New Port Facility Falkland Islands

Supporting statement to variation of condition application

Revision	Date	Description	Prep	Check	App
P02	24-Aug-2022	Final for planning submission	MS	RP	MS

Contract No:	Doc No:	Status	Revision
BAM	BAS.2051	BAS2051-RHD-ZZ-ZZ-FN-YE-5037	S4	P02
RHDHV	PB7829	PB7829-RHD-ZZ-ZZ-FN-YE-5037	S4	P02

QUAY AND CAUSEWAY
GENERAL ARRANGEMENT
DRAWING

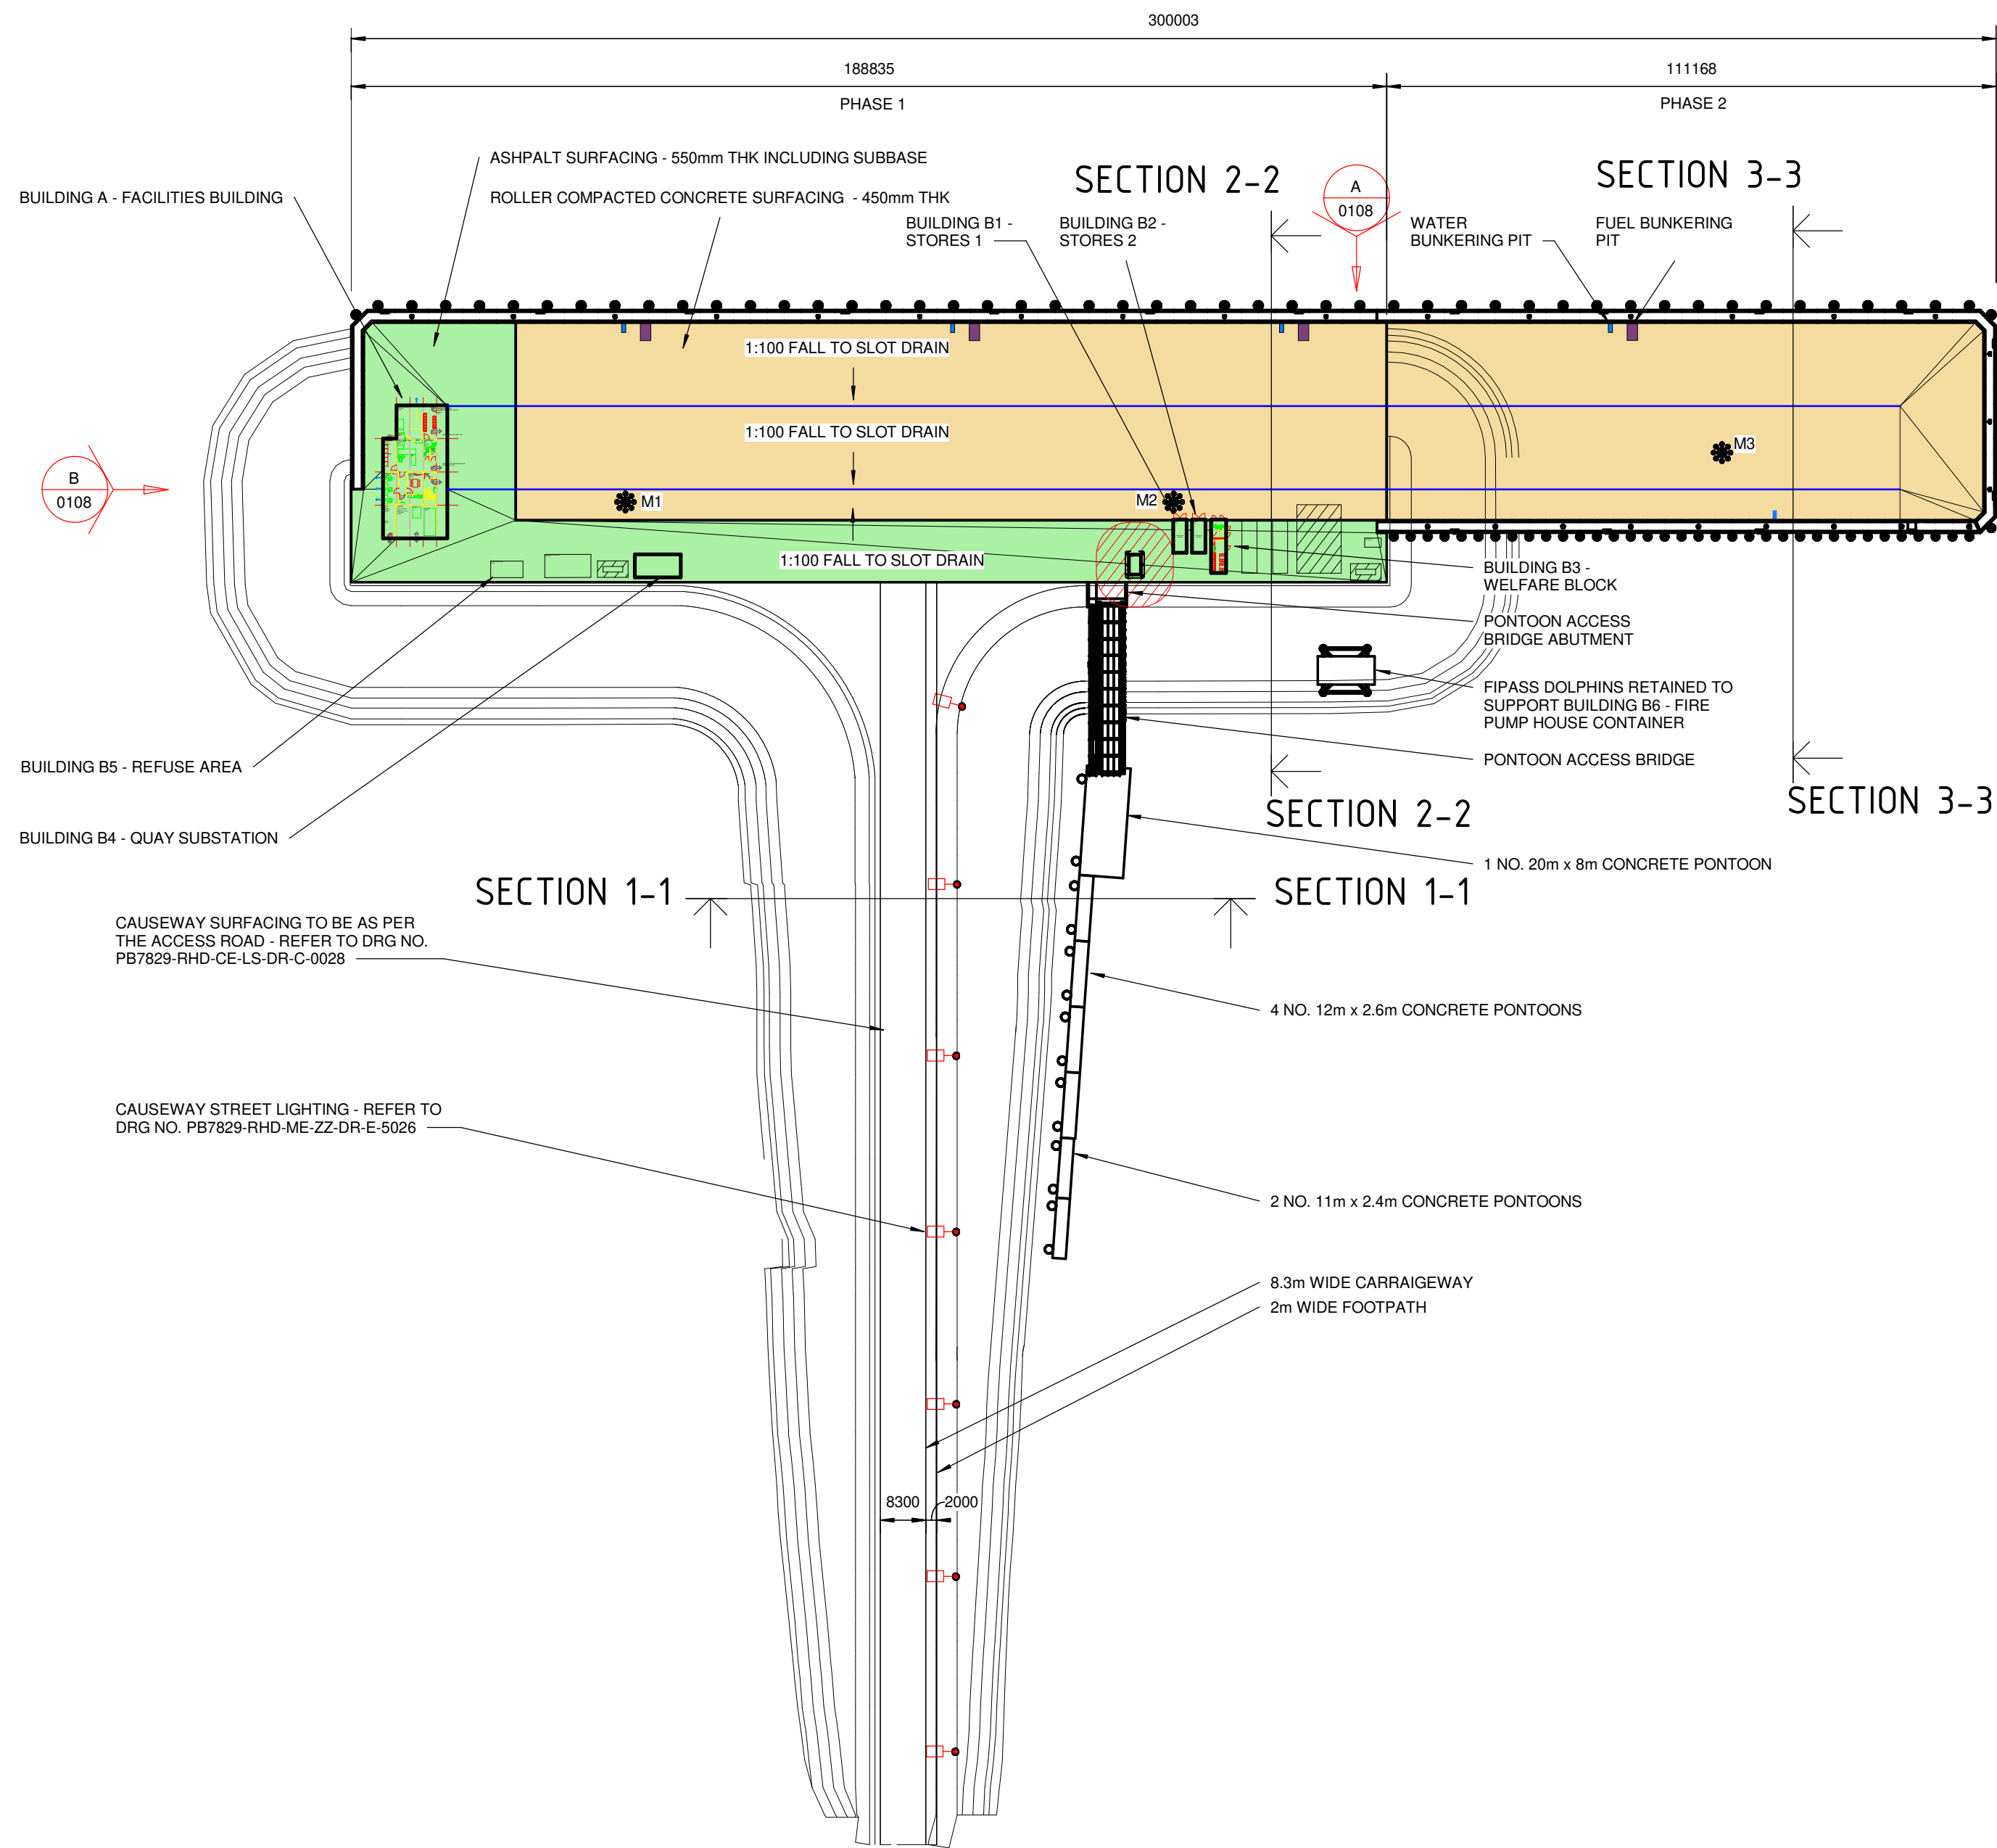
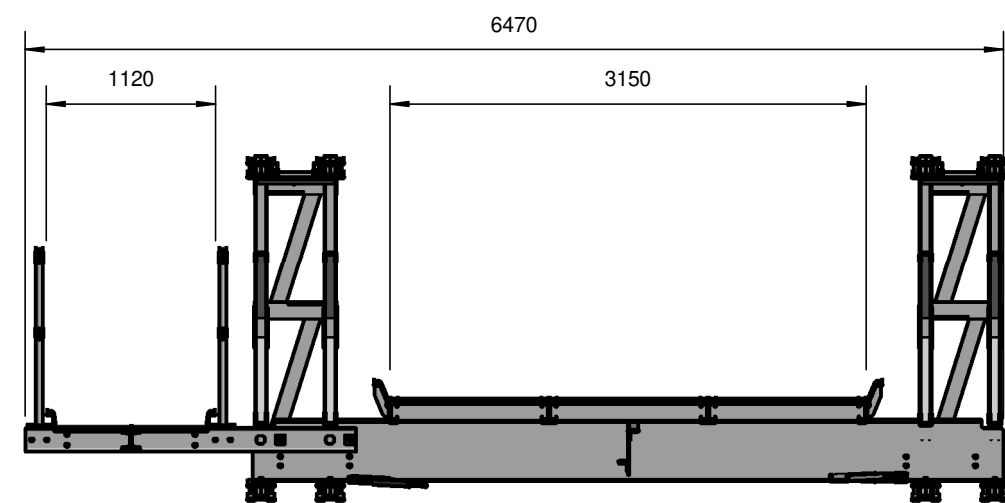
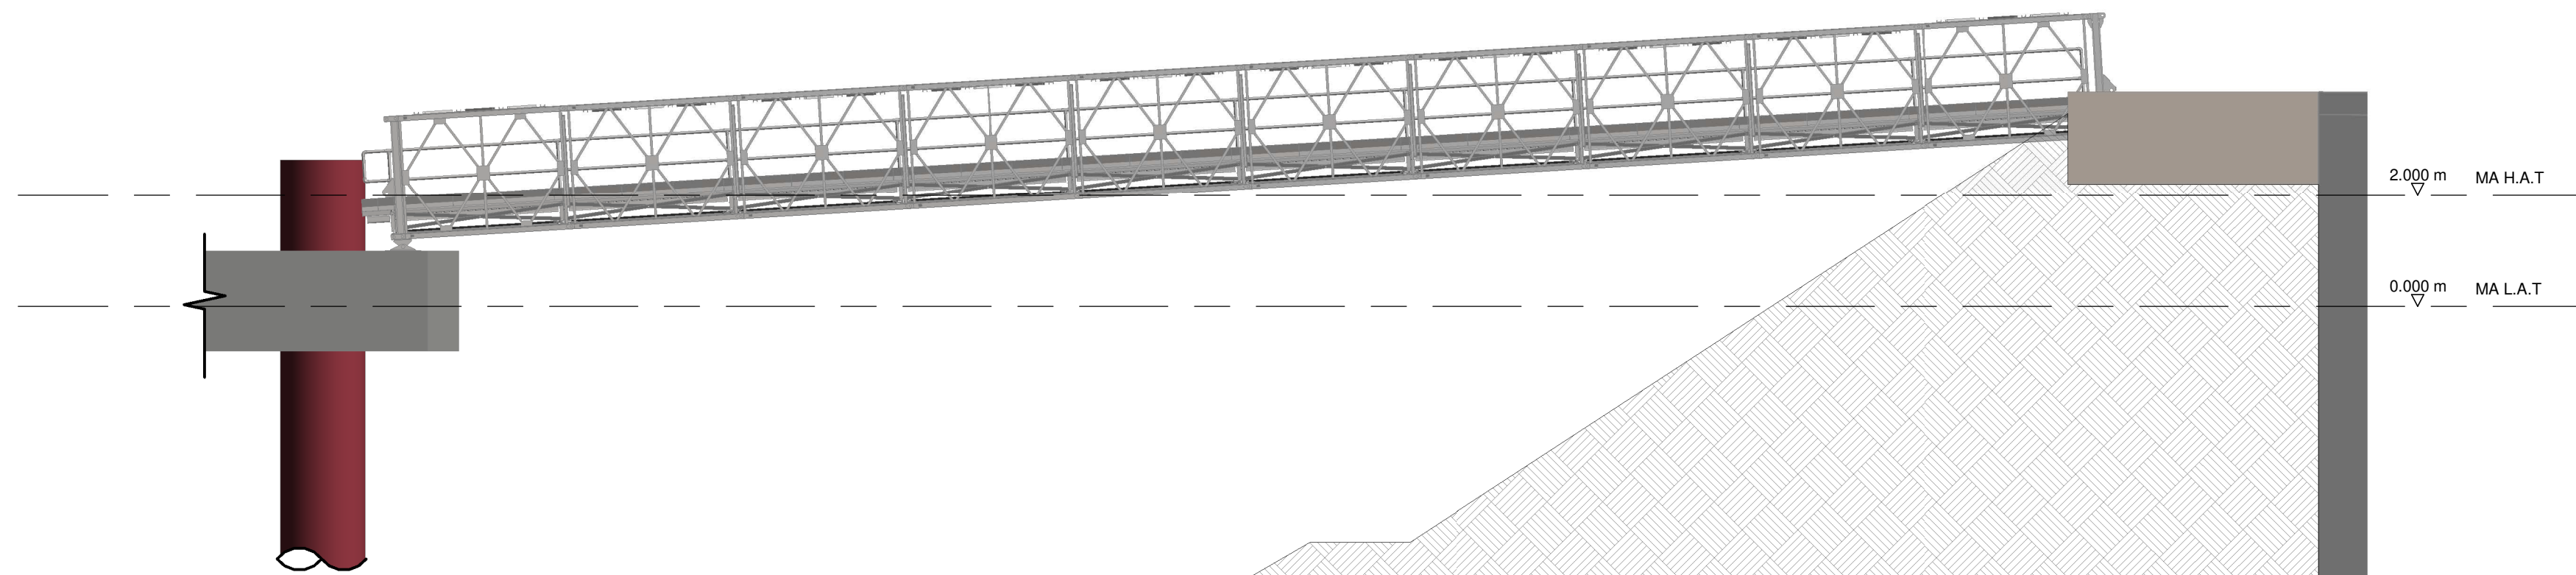
Variation to	Details	Primary condition or content affected
Working platform	<p>It is now proposed that some of the FIPASS barges will be used as working platforms as opposed to a working platform (bund) being constructed from fill material.</p> <p>Section A4.2.8 of the <i>Environmental Impact Statement for scuttling of FIPASS</i> details how this amended approach affects installation of the piles for the quay wall construction and how arisings from the piling will be dealt with.</p> <p>F.I.G. has reviewed the impact to operations at FIPASS and has confirmed that it will provide a tug for operational berthing use for the periods of compromised berthing due to the use of FIPASS barges as working platforms.</p>	<p>Condition 2 – Approved Plans</p> <p>Condition 4 - Construction Works – Construction Environmental Management Plan</p>
Drawings	Approved Plans updated, some of which are included as supporting drawings to the EIS.	Condition 2 – Approved Plans
